Communications Hubs and Network Programme Conclusions on Revised Delivery Plan

DCC Conclusions on the consultation regarding its
revised delivery plan for its Communications Hubs and
Network (CH&N) Programme

Date: 10 February 2023

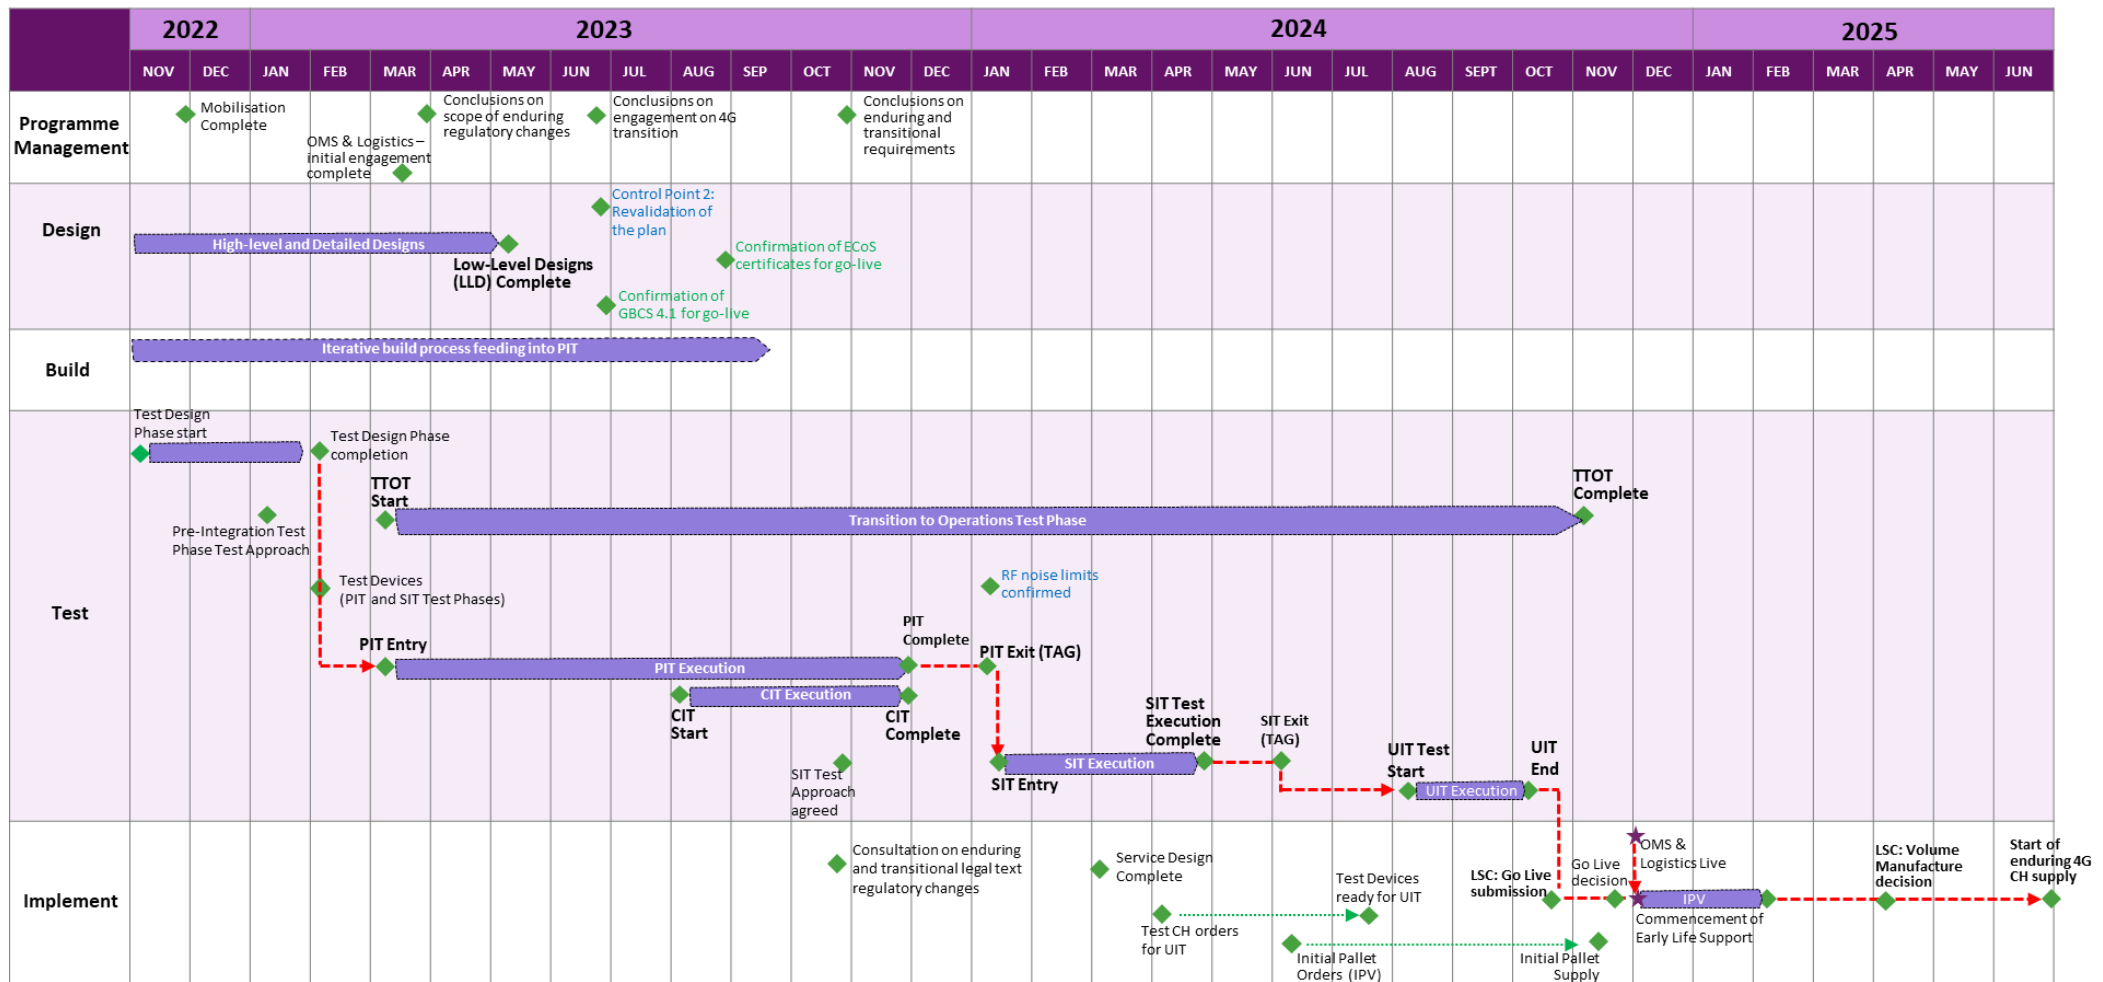
19. One respondent also noted the following inaccuracies between the Plan on a Page (POAP) and the milestones presented in the consultation document:
- the “Test CH Orders” on the POAP is at the start of March 2024, but the milestone in Appendix B is 1st April; and

- the POAP shows the Noise Limit confirmation milestone towards the end of April whereas milestones in the table in Appendix B show the PIT Entry date as the 7th March.

32. We're grateful for respondents identifying inaccuracies between our POAP and the milestone table. We can confirm that the date for Test CH orders should be 1 April 2024 and will update the POAP to reflect this. We have added a line to the description of the Test CH Orders milestone which includes that the delivery of Test CHs within 12 weeks of the date they are ordered.

33. In contrast to the position consulted on, the date by which RF Noise Limits will be confirmed will be at the end of PIT. This is as we set out in our initial plan published on 11 June 2021, as opposed to start of PIT, as presented in the consultation on this updated plan. DCC has corrected this error in both the POAP and the Milestone table, with the correct date now being 10 January 2024. This date marks the point at which DCC will have published the Intimate Communications Hub Interface Specification (ICHIS) – the technical document managed by DCC which sets out formal noise limits. In advance of this DCC will work with its service providers and industry to determine the appropriate limit prior to formal consultation. DCC can confirm that it expects to have an initial view on noise limits established in Q2 2023, and we plan to share this information with the ICHIS working group. Stakeholders will have the opportunity to test against these indicative noise limits at DCC Test Labs from Q3 2023, using any feedback from this testing to inform our final position on RF Noise Limits.

- DCC will be adding a new milestone which is the latest date by which it will confirm its current assumption to use GBCS version 4.1. We have added this to the plan for 30 June 2023.

- DCC will also add a new milestone which is the latest date by which it will confirm its current assumption to use ECoS certificates. We have added this to the plan for 31 August 2023.

- In order to make full use of customer feedback on and engagement on transitional issues, we have moved Control Point 2 from the date of completion of Low-Level Design (8 May 2023) to 30 June 2023, to coincide with the issuing of our conclusions on our approach to transition. This provides DCC with time not only to review the complete low-level design and assess whether this impacts plan delivery, but to also assess transitional issues (for example the duration of IPV);

- We have amended the description of our final milestone in the plan – the 30 June 2025 date following the decision to commence mass-manufacture of 4G CHs. To add a more precise definition, in line with the contracts DCC has agreed with its Service Providers, we now describe it as 'Point at which unconstrained volumes of 4G CHs will be in the UK with logistics providers ready for delivery to DCC customers', to reflect that it is from this point that 4G CHs will arrive in unconstrained volumes with DCC logistics providers and are ready for onward delivery to DCC customers.

144. Where respondents have highlighted inconsistencies between the POAP and the Milestone table, we have corrected the POAP so it accurately reflects the Milestone plan.
